Final Report of Structural Special Inspections

Project: *Sheridan Heights*
Location: *135 Sheridan St.; Portland Maine*
Owner: *Sheridan St., LLC*
Structural Design Professional in
Responsible Charge: *David A. Price, PE / Price Structural Engineers, Inc.*
Date: *September 30, 2008*

AS-BUILT FOUNDATION
PART. PLAN

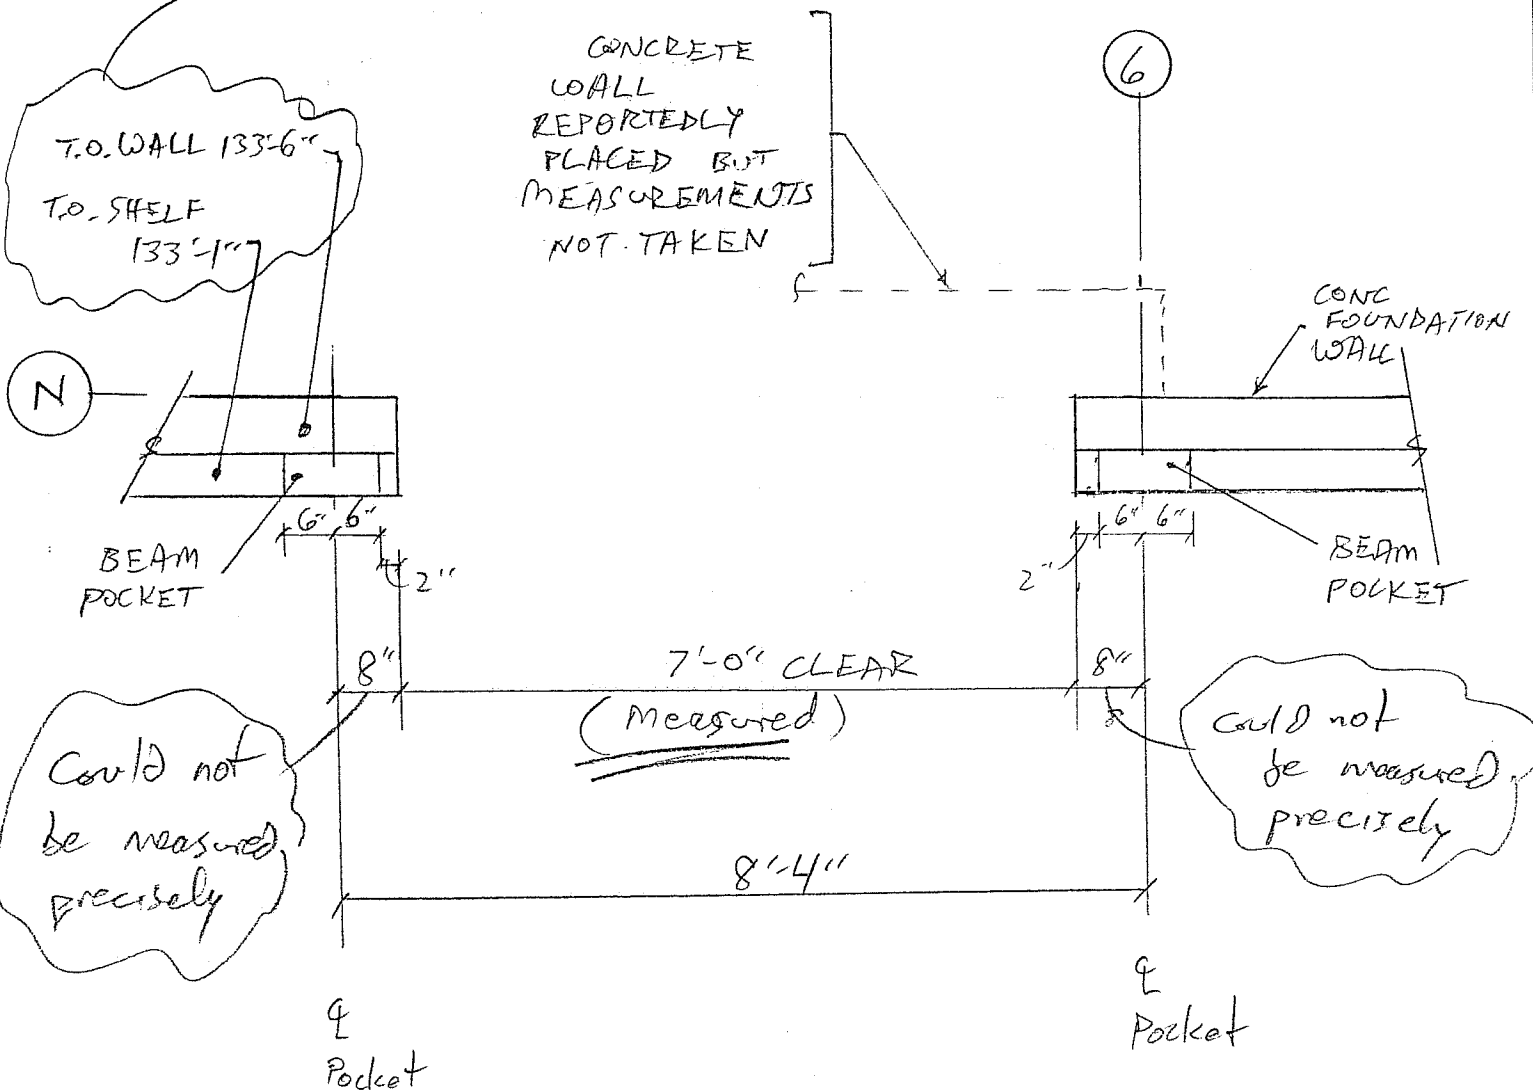
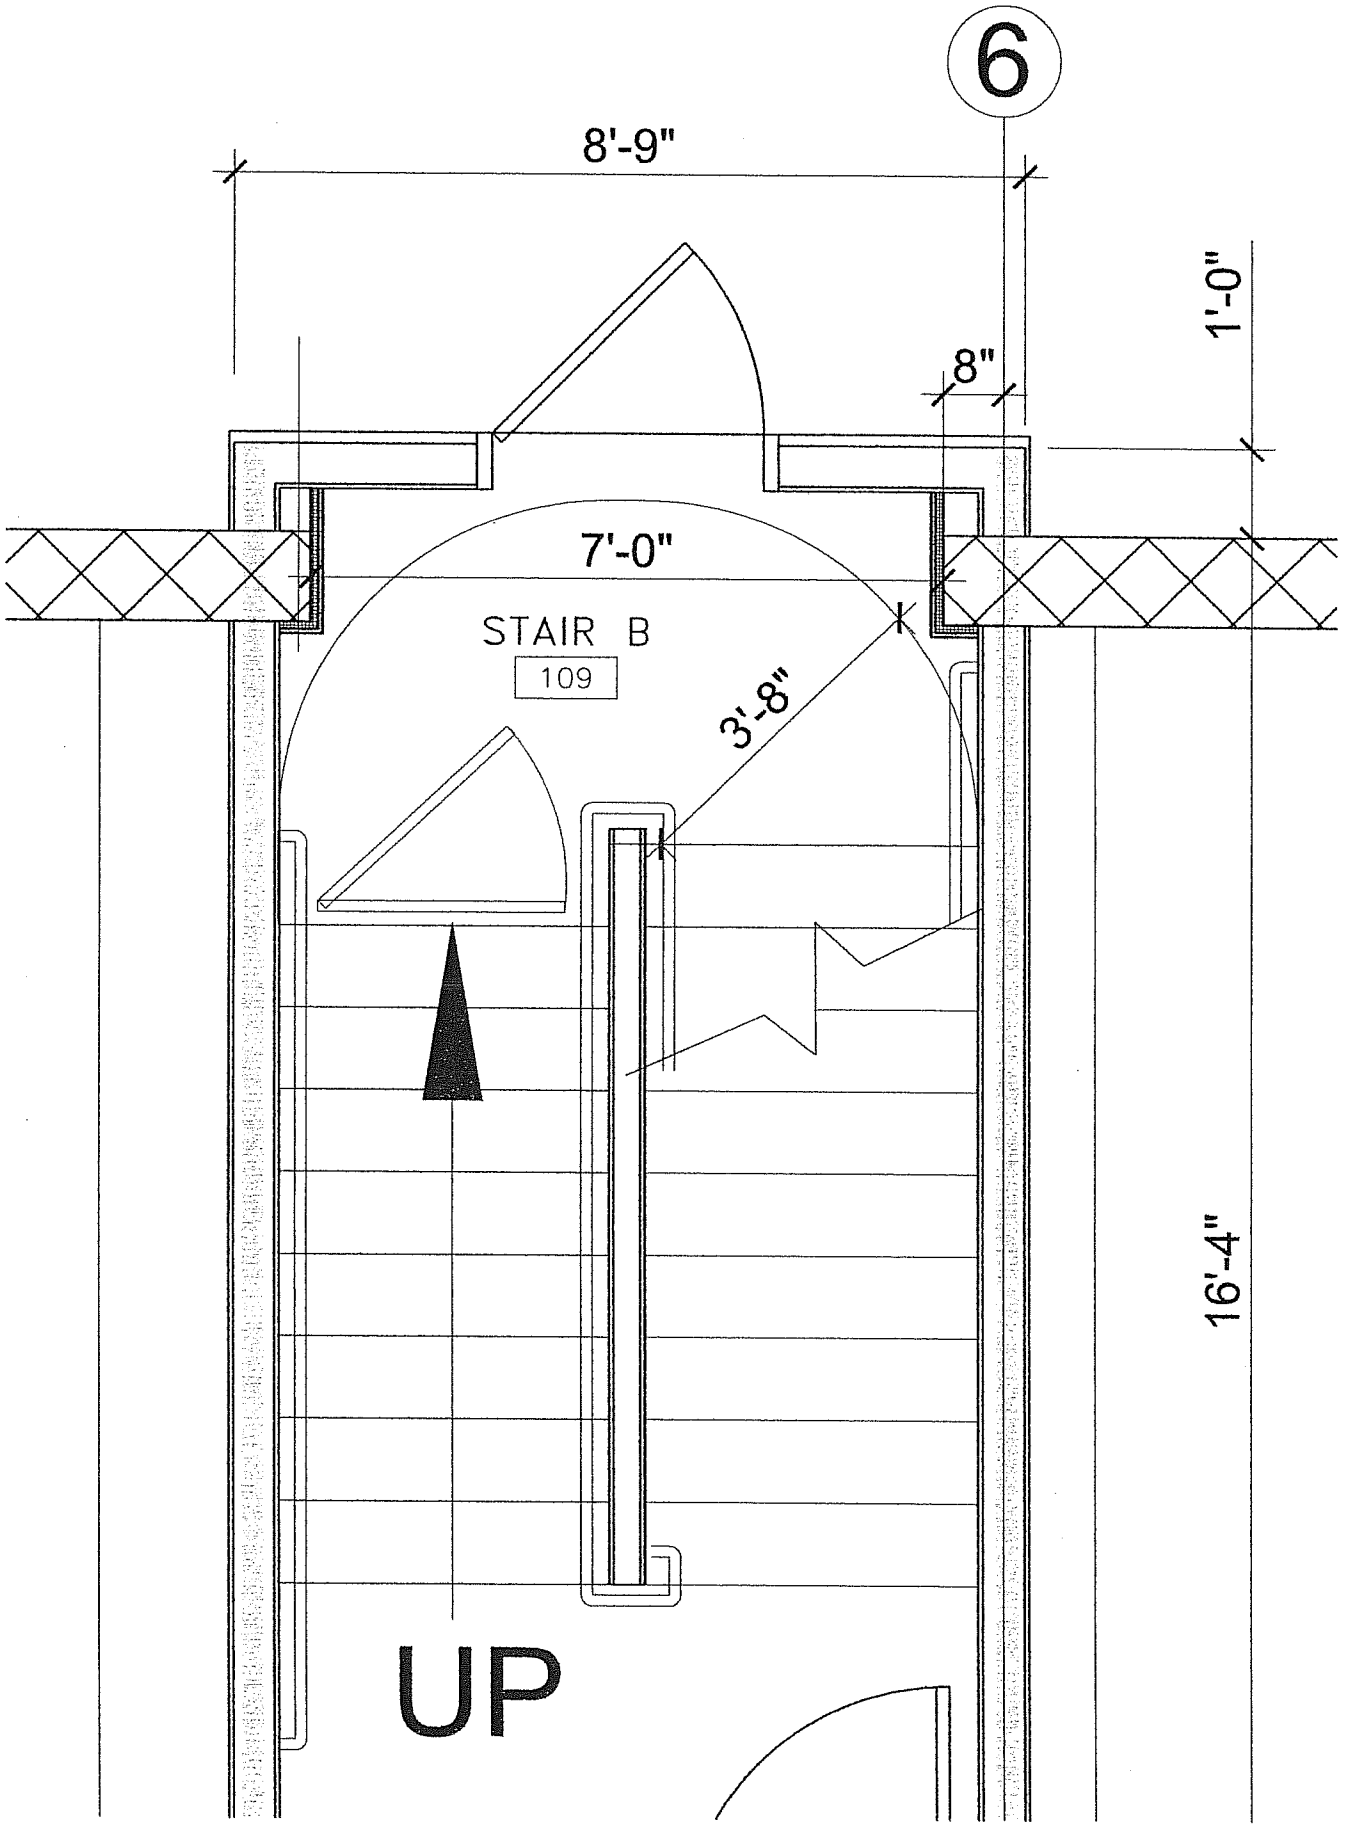
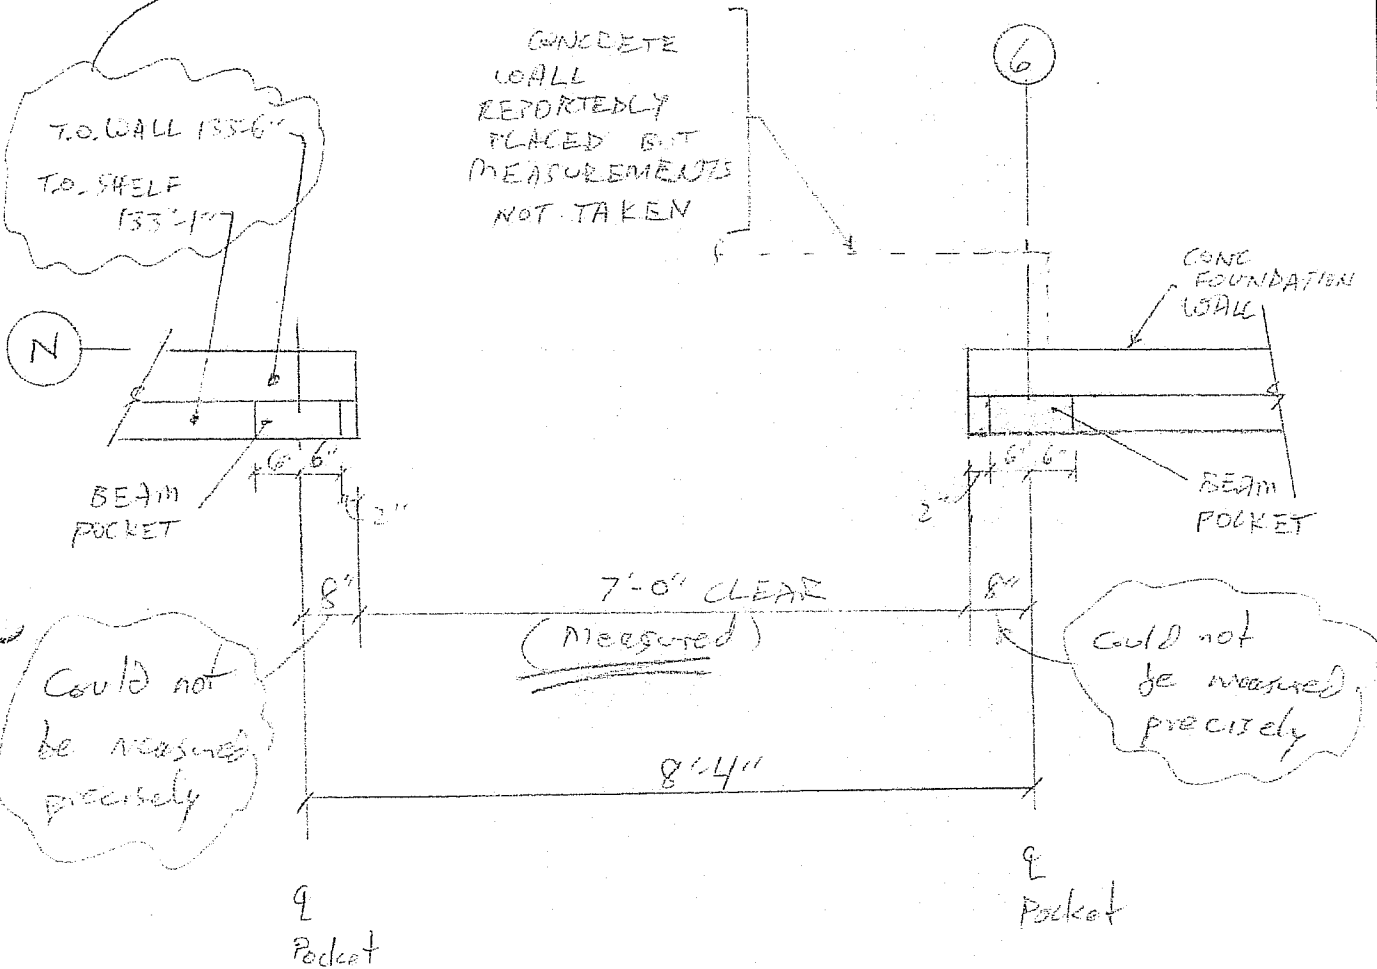
4. Bill said that the foundation wall at Gridline "N" had been placed the previous day (Wednesday, September 12).
5. While at the project site I measured 7'-0" clear opening between the foundation walls at Gridline N/6 to N/5.6 at the location of Stair B (See attached "As-Built Foundation Part. Plan" hand sketch). This is less than what is needed to accommodate the stair indicated on the Architectural Drawings.

Ryan – the attached sketch appears to be what was constructed based on my site visit today. Your recommendations would be appreciated.

7. Afterward, I sent a copy of the attached "As-Built Foundation Part. Plan" sketch to Ryan Senatore at TFH who had indicated he may be able to find a solution. Fortunately, Ryan did find a solution and a copy of his recommendation is attached.

1. The contractor must obtain his own dimensions of the existing concrete at stair B and verify that the solution recommended by TFH at stair B will be compatible with the current design documents or if any further adjustments are necessary. This verification shall be provided to the owner and the architect as soon as possible.

Photo 5 – Large discharge pipe extending through footing at grade N. Footing should have been stepped at this location (Note B15/ S1.0).

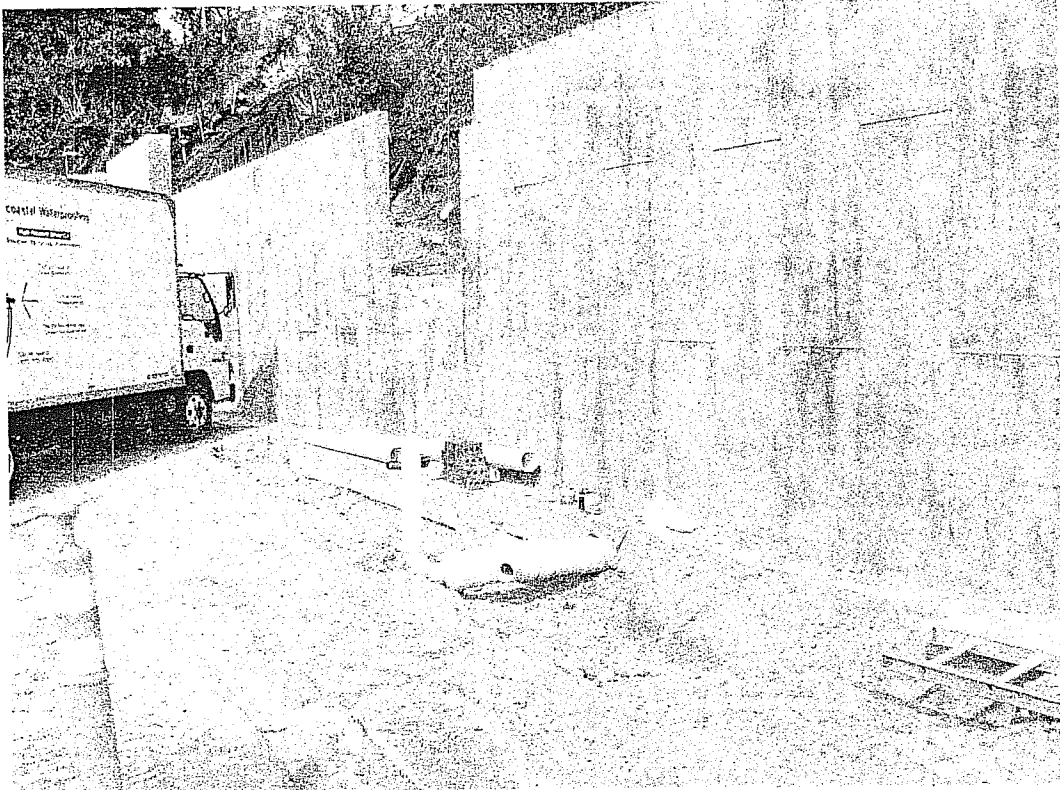
6. A large pipe was observed at gridline N that extended directly into the footing. This does not agree with note B15 on drawing S1.0. Fortunately, the exterior grade is lower at this location and therefore the stresses on the footing are reduced at this area compared to other areas. Also, the foundation wall is fully reinforced and should be able to span over the footing at this area (photo #5 and# 6).

Photo 1 – Front entrance piers near grid AA

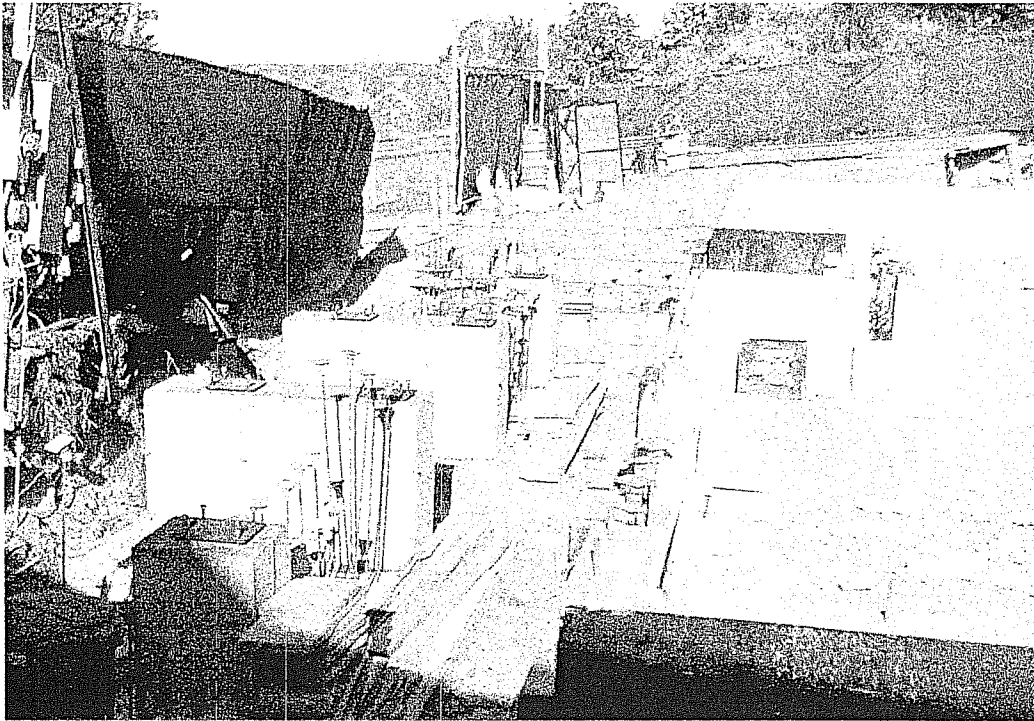
2. There appears to be two concrete piers that were missing at the front entrance area. These are both located on gridline AA and are indicated as "P2 (SIM)" on plan view Detail H6/S3.3. These piers do not support structural steel columns, however, they do support masonry columns.

1. The two concrete piers that are located on gridline AA and are indicated as "P2 (SIM)" on plan view Detail H6/S3.3 need to be installed. Vertical reinforcement should be the same as indicated for Pier Detail P2. Holes for the vertical pier reinforcement will need to be drilled into the footing using "AC 100 plus" epoxy anchoring cement (by Powers Fasteners) or an approved alternate epoxy. Depth of embedment should not be less than 10 inches and installation, including hole diameter, must be in accordance with manufacturer's directions.

Photo 6 – Wall panel needs framed lintel to span over concrete wall opening. Rough opening size of equipment to be installed in opening must be obtained prior to installing framed lintel.

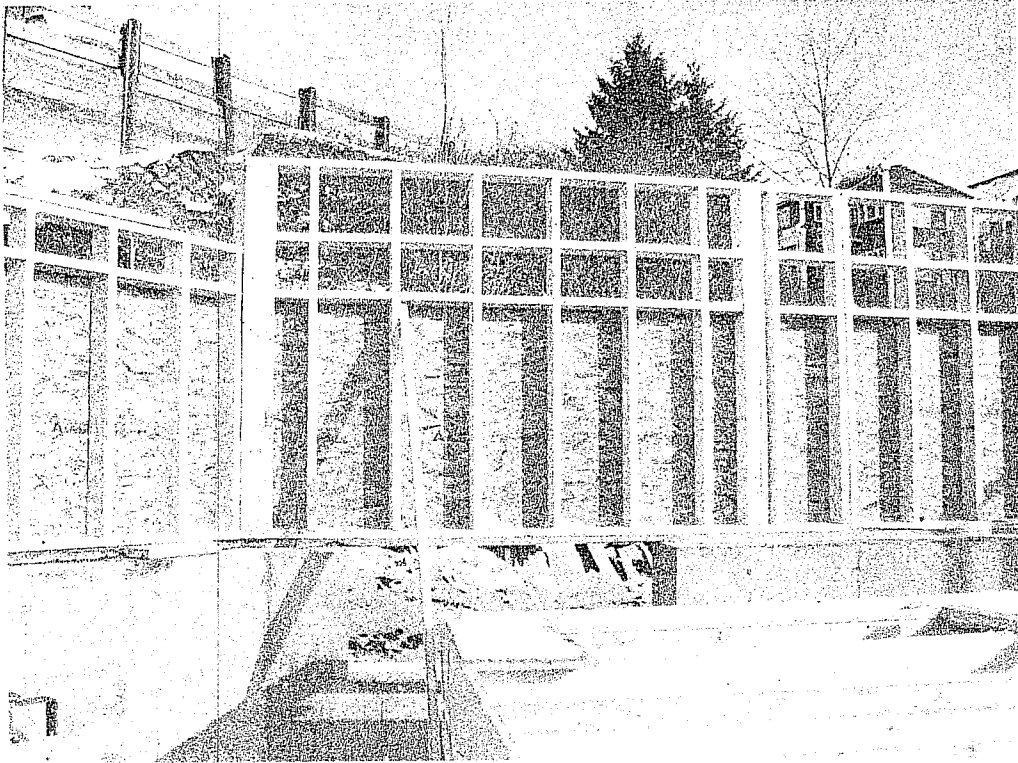
3. Wall panel needs framed lintel at 2nd floor grid N/2 to span over concrete wall opening. Rough opening sizes of equipment to be installed in opening must be obtained prior to installing lintel. See Architectural Elevation 1/A2.1 for wall elevation indicating wall opening at this area. Frame lintel opening using Type "L3" lintel (3 – 2x10's) per detail Schedule D5/S5.1 and detail D6/S5.1.

Photo 7 – Centerline of B712 is more than 6" from face of CMU wall. See attached repair sketch details.

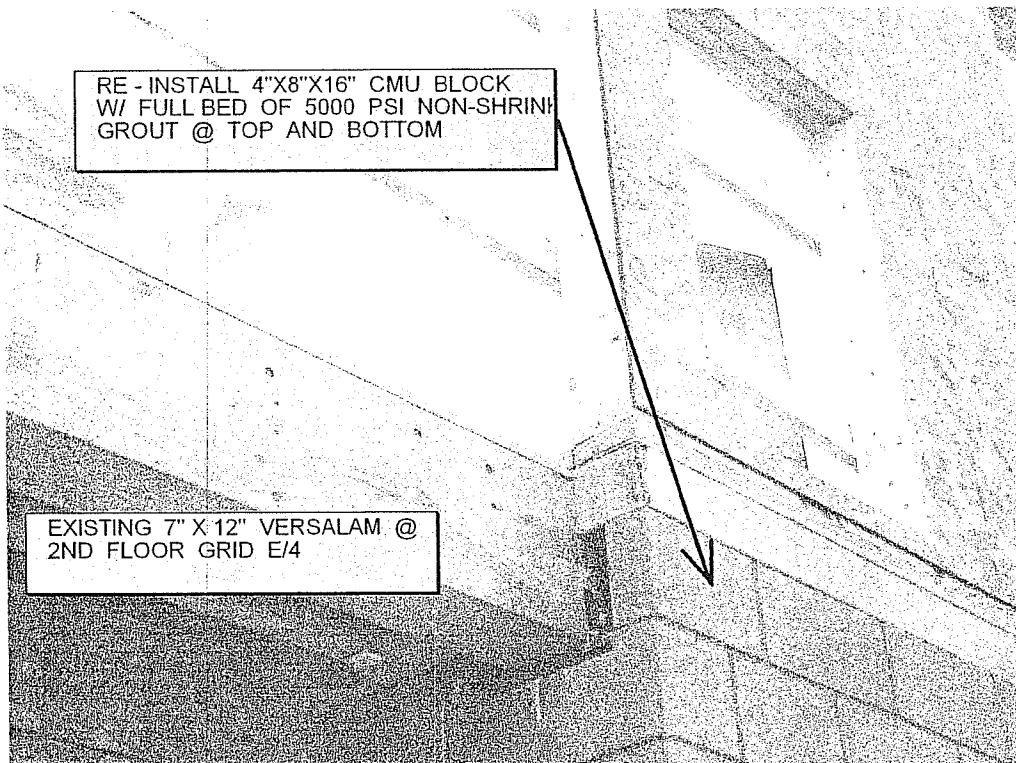
4. Versalam Beam "B712" located near grid E/4 on the second floor (reference plan H7/S5.5) was installed with centerline at more than 6" from face of CMU and therefore cannot support any portion of the exterior wall above. The wall above is load bearing in that it supports joists at the 3rd, 4th and roof levels. See attached repair details **SK-S1** and **SK-S2** for necessary repairs at this area. Existing anchorages of B712 beam shall not be modified.

Photo 8 – Stairs stringers not bearing directly over double 2x primary framing. Ledger must be bolted to primary framing

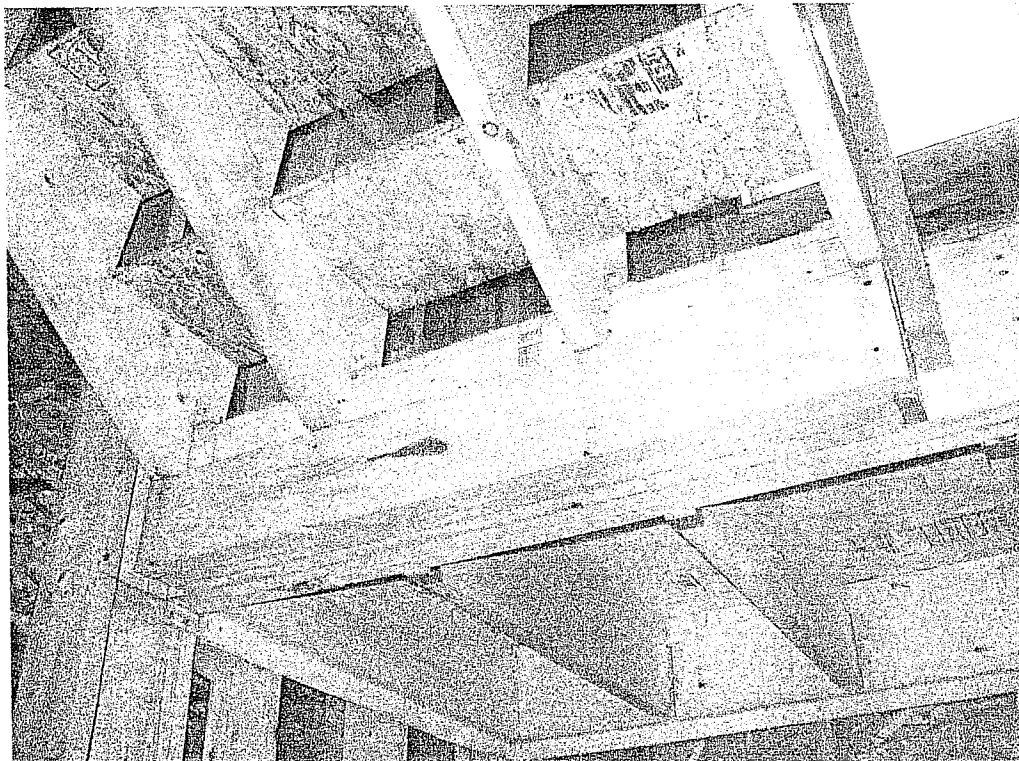
1. The stairs stringers at the ground floor landing at Stair A was supported by a 2x ledger which is face nailed to the front of the primary beam and not bearing directly above the continuous primary beam itself . At the ground floor level of stair A , the header that was supporting the stair stringers is now bolted.
2. The two concrete piers that are located on gridline AA and are indicated as "P2 (SIM)" on plan view Detail H6/S3.3 needed to be installed. These non-load bearing concrete piers (supports masonry loads but does not support floor loads above) have been installed. Brick masonry was being installed during the site visit in a heated and tented space.
